State of North Carolina
Department of Natural Resources and Community Development
Winston-Salem Regional Office

LETTER OF APPROVAL WITH MODIFICATIONS

PROJECT NAME: Peidmont Sanitary Landfill

MODIFICATIONS REQUIRED FOR APPROVAL

Figure 6.60a Temporary sediment trap.

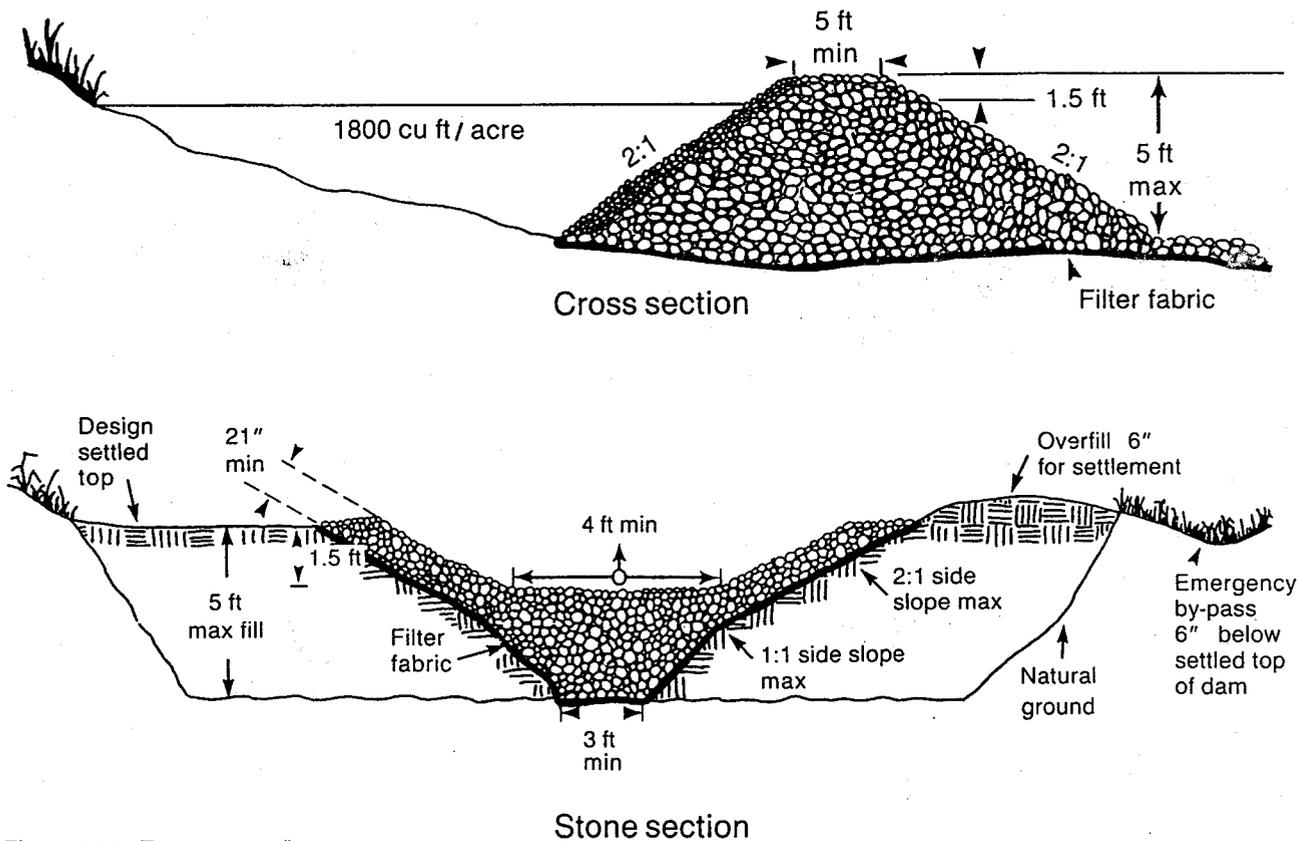
1. Rip rap check dams will be substituted for silt fence northeast of the office, southwest of the maintenance area and west of module 5. The dams 5 will be 4 feet tall and will be constructed per the attached sheets 6.60.2 - 6.60.5.
2. Runoff from proposed maintenance area must exit at grade point and must not be diverted over fill slopes.
3. This plan is approved with performance reservations. Should portions of the plan be found inadequate to meet the requirements of the Sedimentation Pollution Control Act, addition will be required.
